WAYZATA PLANNING COMMISSION

Meeting Agenda

MEETING DATE: August 17, 2026	AGENDA ITEM: 6.b
TITLE: Consider Variance Application for Parking Lot Expansion at 109 Bushaway Rd (Lake Minnetonka Dental)	
PREPARED BY: Haily Hedblom, Planner	
REVIEWED BY: Haily Hedblom, Planner	
60 DAY DEADLINE: September 20, 2026

**Staff Report
Wayzata Planning Commission
August 17, 2026**

Figure 1: Depiction of Impacted Critical Root Zones (yellow) and Structural Root Zones (red)

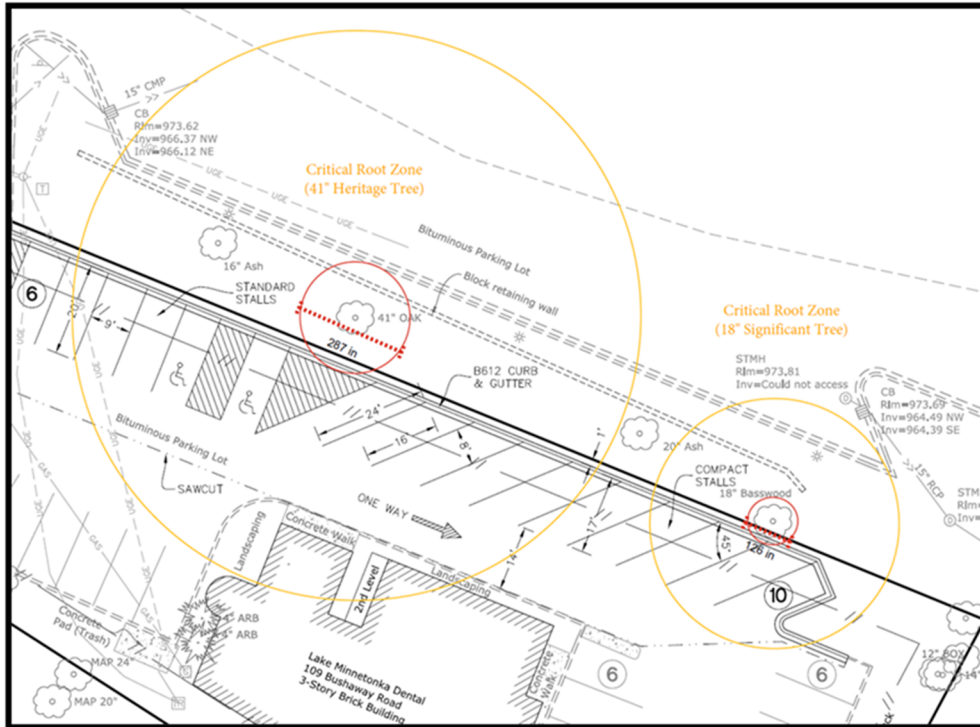
The Ordinance defines “Structural Root Zones” (SRZ) based on a calculation of trunk diameter (depicted in red). This much smaller area represents the roots needed for keeping a tree upright. Any disturbance to this area can compromise a tree’s structural integrity. When a project proposes any impact to the SRZ of a tree, that tree must be removed before work begins and the DBH is counted toward the project’s removal threshold (§936.06.E).

1. The Applicant must demonstrate a “lack of alternatives” as required under §936.06.A.01.
2. A tree replacement plan must be provided in accordance with §936.09.
3. The property owner of the two trees impacted by the project must provide written permission for their removal.

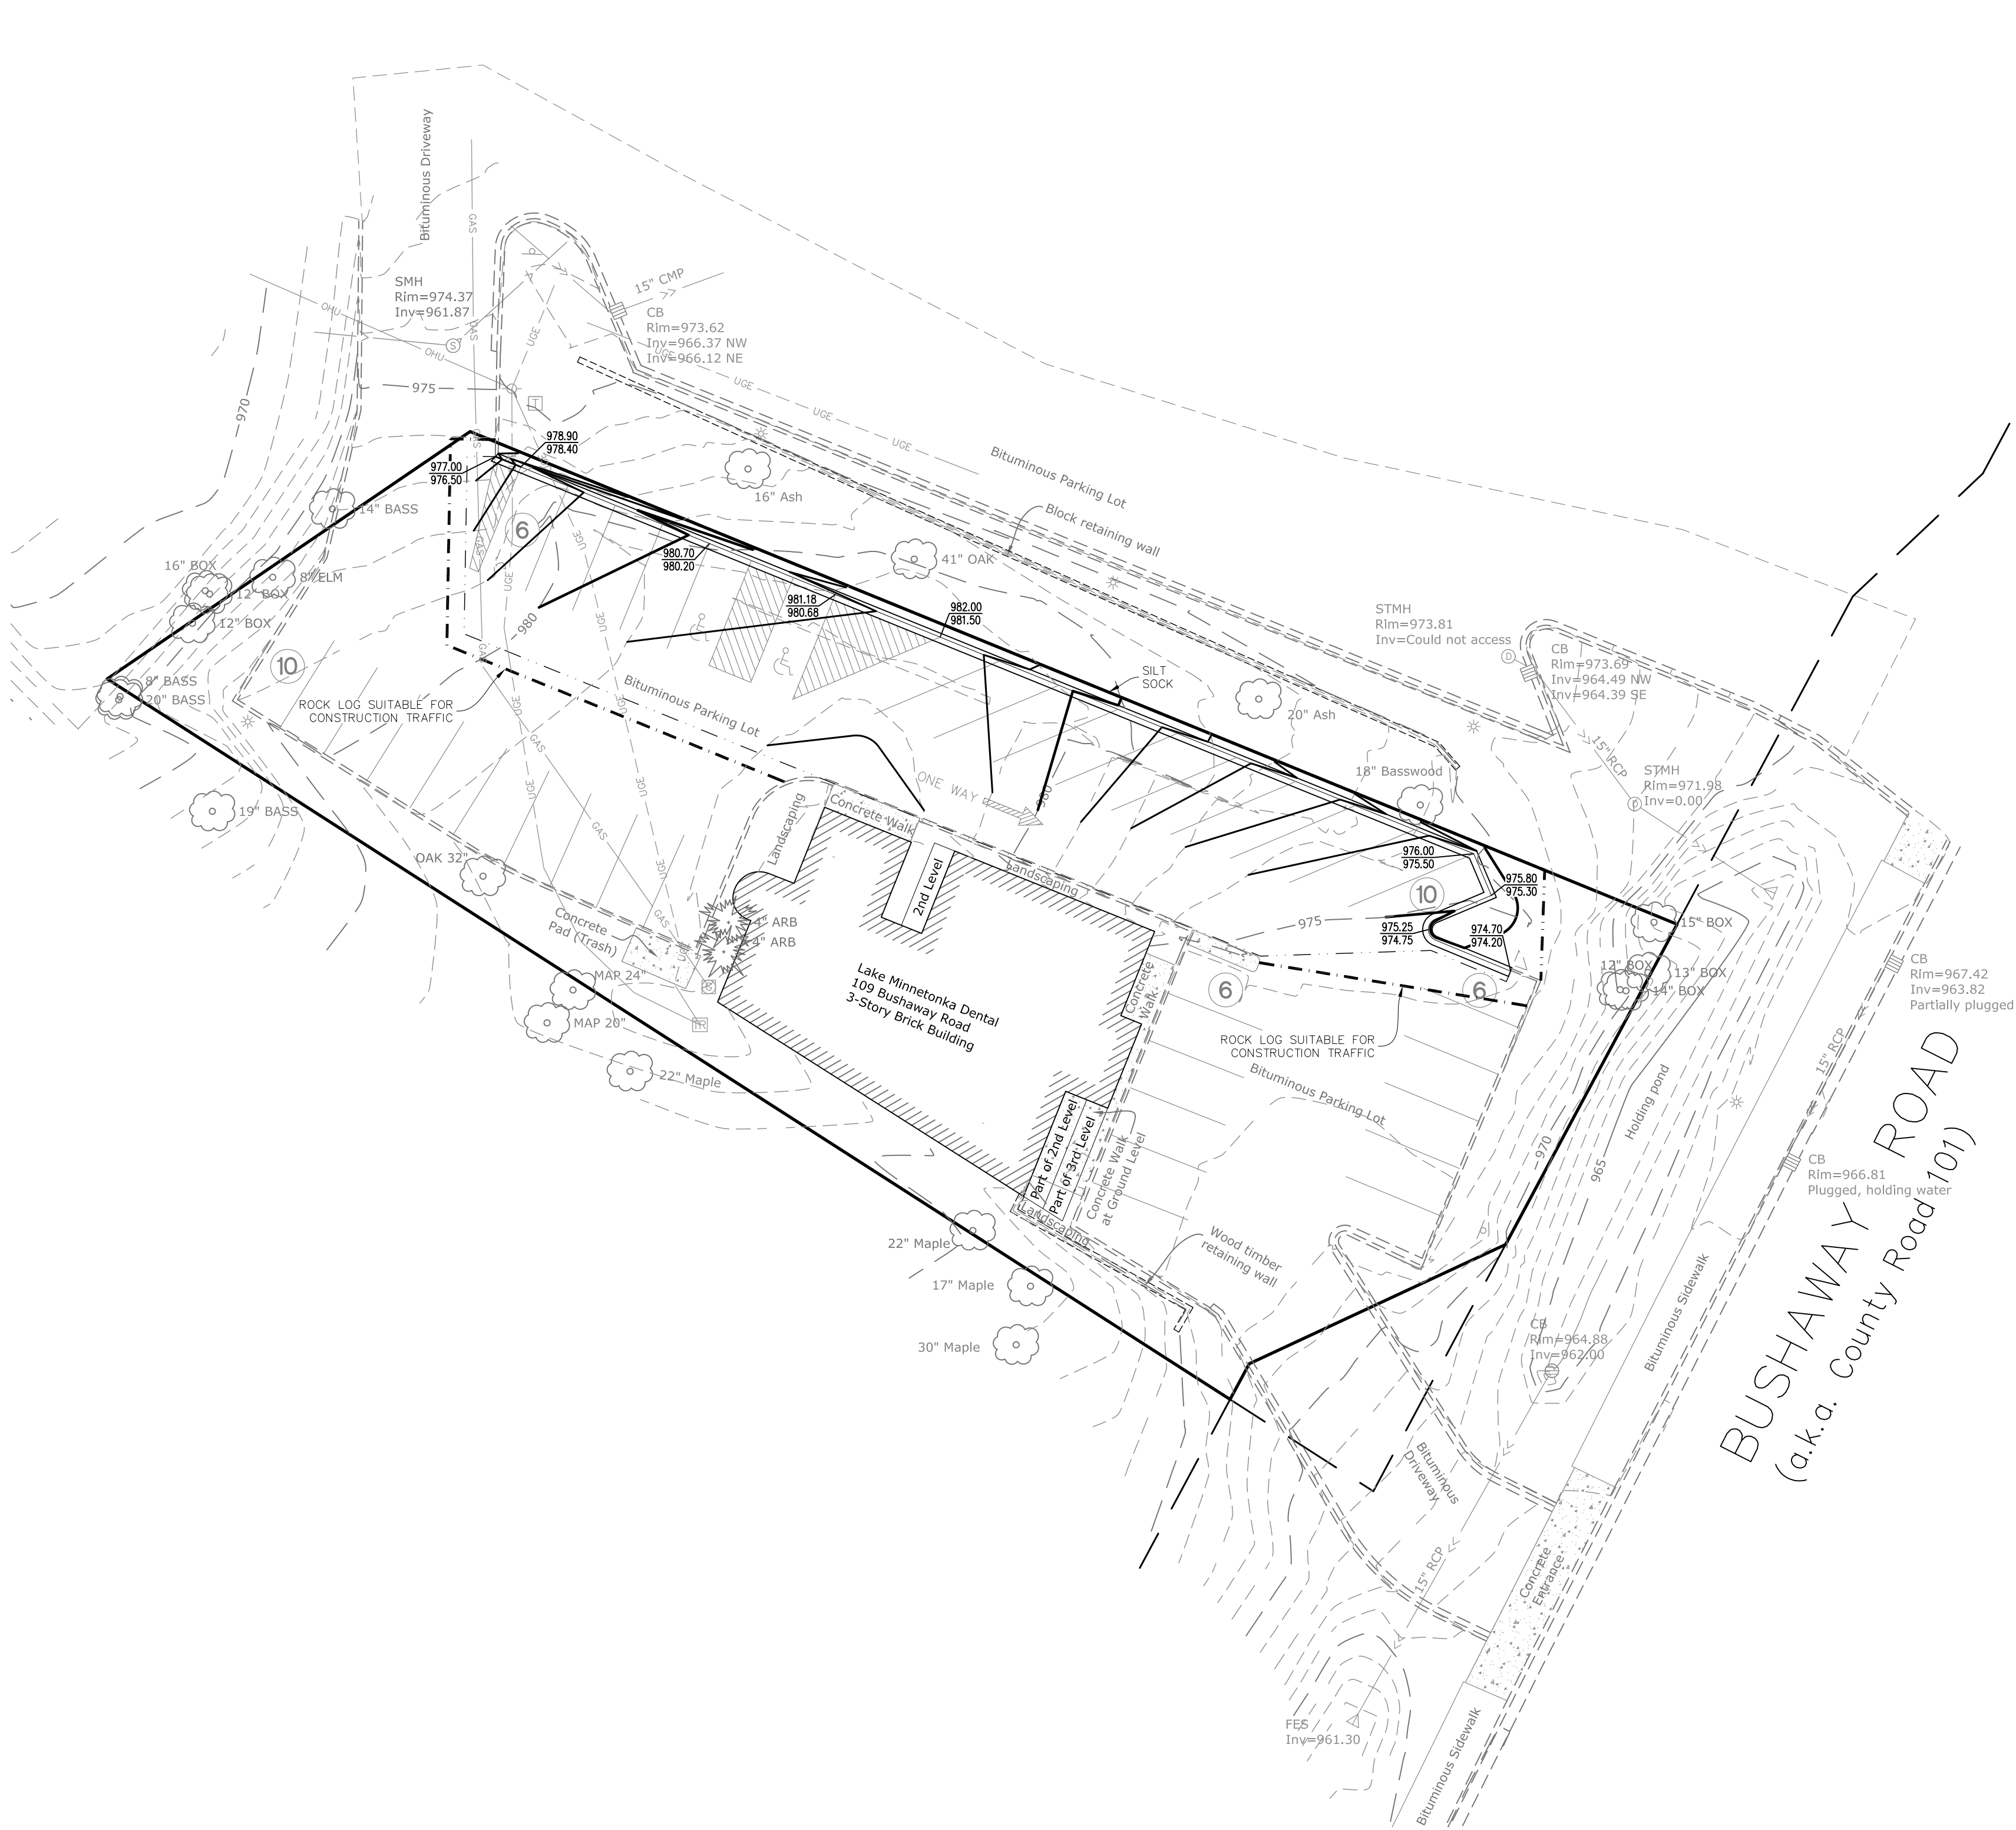
The proposed plans depict a new parking setback distance of 1 foot along the North property line. All other parking setback distances will remain as existing.

Ordinance requires all exposed parking areas of four or more required spaces to be landscaped on all sides. The plans submitted do not include proposed landscaping and due to the tight configuration requested, and staff does not see a way to incorporate the required screening. The adjacent property to the North does include a landscaped area that is greater than the ten-foot setback distance. The two parking areas are also visually separated by a retaining wall.

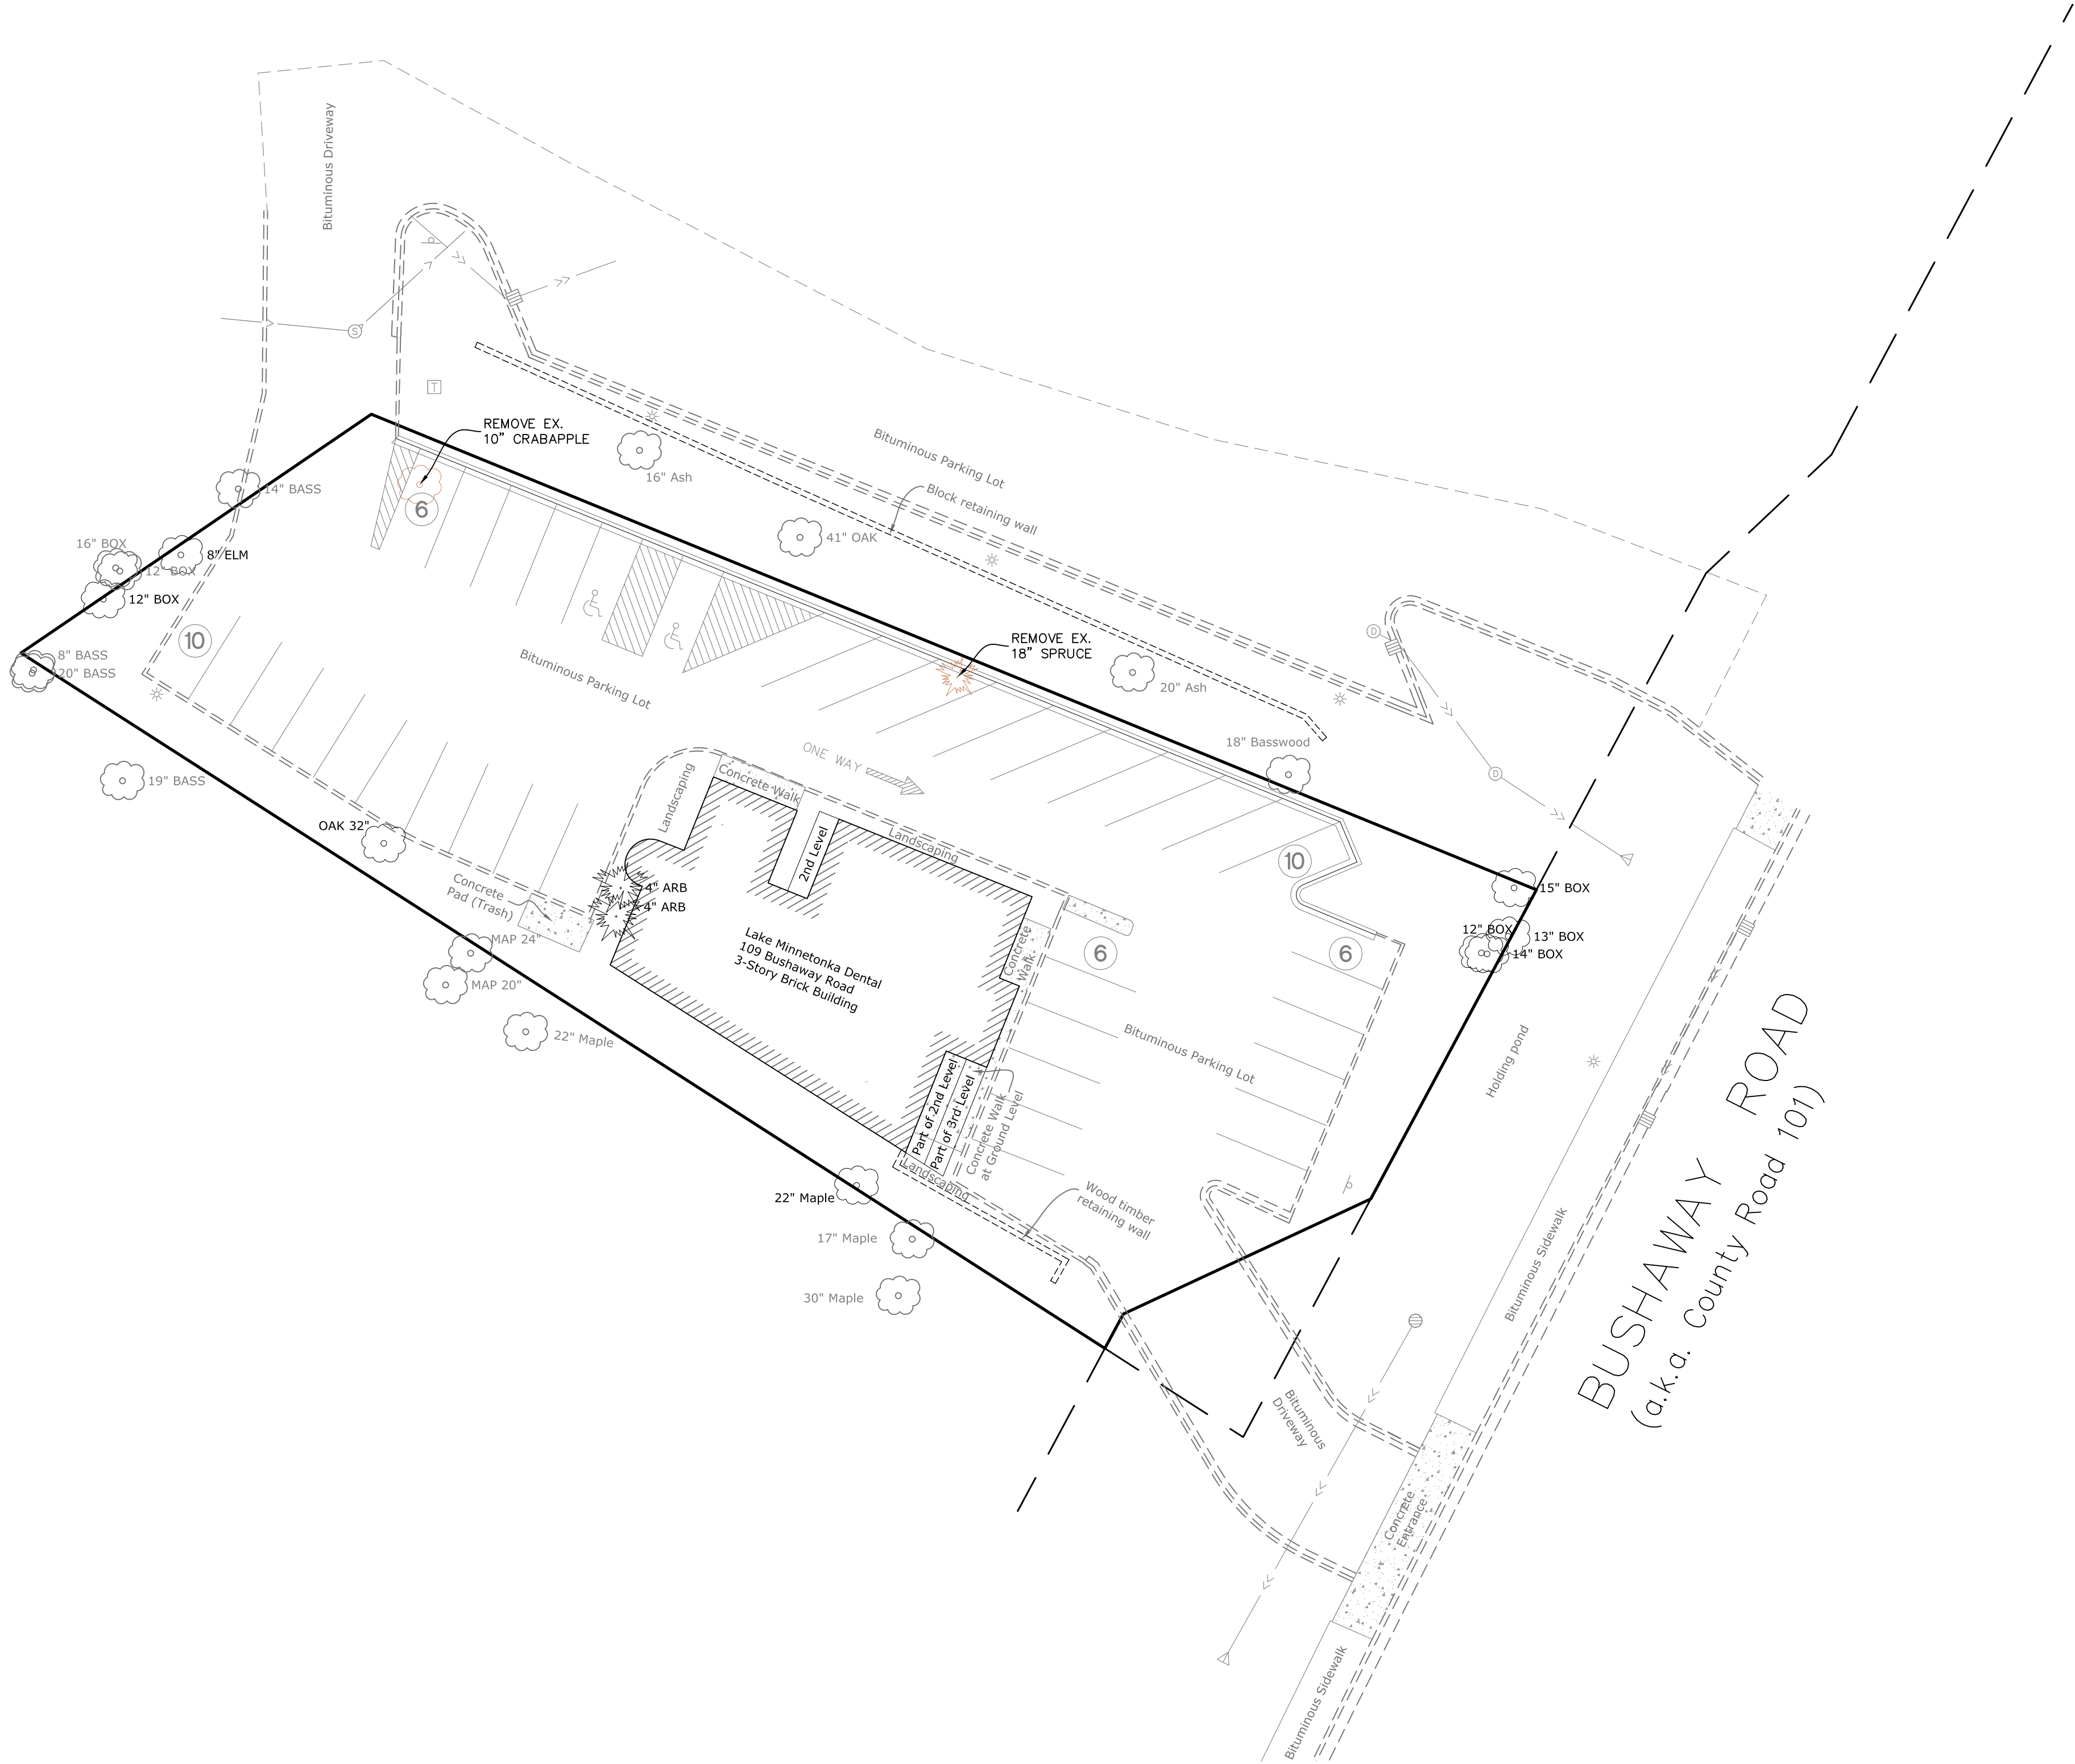
City Code limits the slope of any parking area or portion thereof to no more than five percent (§920.05.E.10). The proposed grading and erosion control plan in the Application does not indicate the slope of the parking area. Staff notes that such grading would need to either comply with this standard or the Applicant would need to apply for an additional variance before the project could proceed.
